JAMES A. FITZPATRICK NUCLEAR POWER PLANT

Amendment No. 52
License No. DPR-59

ATTACHMENT TO LICENSE AMENDMENT NO.52
FACILITY OPERATING LICENSE NO. DPR-59
DOCKET NO. 50-333

SAFETY EVALUATION BY THE OFFICE OF NUCLEAR REACTOR REGULATION
SUPPORTING AMENDMENT NO.52 TO FACILITY OPERATING LICENSE NO. DPR-59
POWER AUTHORITY OF THE STATE OF NEW YORK
JAMES A. FITZPATRICK NUCLEAR POWER PLANT
DOCKET NO. 50-333

FIGURE 3.5-1 MAXIMUM AVERAGE PLANAR LINEAR HEAT GENERATION RATE (MAPLHGR) VERSUS PLANAR AVERAGE EXPOSURE

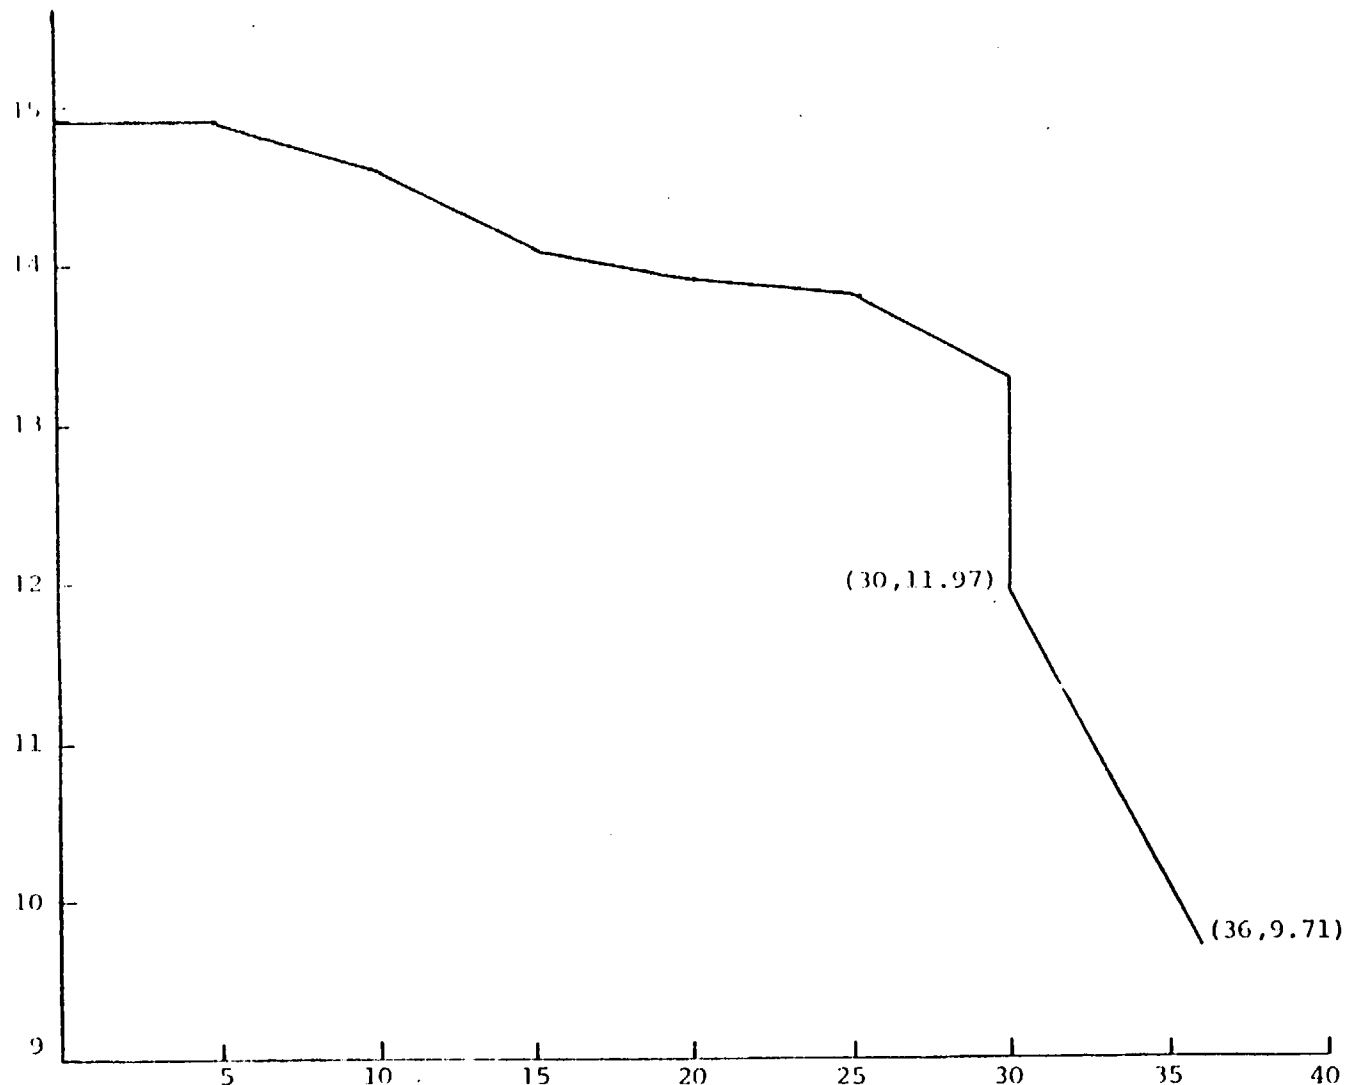
The proposed new MAPLHGR limits are calculated out to higher exposures (from 30,000 MWD/STU to 40,000 MWD/STU) by the previously approved methods initially used for the fuel with exposures up to 30,000 MWD/STU. The changes in the two figures (Figures 3.5-1 and 3.5-2) are the result of extending the MAPLHGR limits to 36,000 MWD/STU for type 2 and 3.7 x 7 fuel.

Although the methodology used is generally applicable for an average planar exposure up to 36,000 MWD/t, the staff believes the effects of enhanced fission gas release in high burnup fuel (above 30,000 MWD/t) are not adequately accounted for in your submittals. To compensate for this deficiency, the staff has estimated the amount of MAPLHGR limits in Figures 3.5-1 and 3.5-2 of the proposed Technical Specifications should be reduced to assure the peak cladding temperature and local oxidation are below the limits allowed by 10 CFR 50.46. The reduction is based on the results of comparative calculations of fuel volume average temperature performed by General Electric using GEGAP III with and without an NRC correction for enhanced fission gas release and the relationship between peak cladding temperature and MAPLHGR increase presented in NEDE-23786-1-P. In estimating the MAPLHGR reduction, the staff conservatively assumed the change in volume average temperature can be translated

These MAPLHGR reductions to the licensee's proposed Technical Specifications in Figures 3.5-1 and 3.5-2 assures that the cladding temperature and local cladding oxidation would remain below the 2200°F (peak cladding temperature) and 17 percent (local cladding oxidation) limit allowed by 10 CFR 50.46 when the effects of enhanced fission gas release above 30,000 MWd/t are conservatively accounted for.

directly into a peak cladding temperature change. Table 1 gives the percent reduction in MAPLHGR as a function of exposure above 30,000 MWd/t for type 2 and 3 7 x 7 fuel in your submittals. We have limited the extension of the MAPLHGR to 36,000 MWd/t to account for the uncertainties in enhanced fission gas release above this exposure.

Exposure MWd/t	30,000	32,000	34,000	36,000
Reduction MAPLHGR, %	10.0	13.33	16.67	20.0
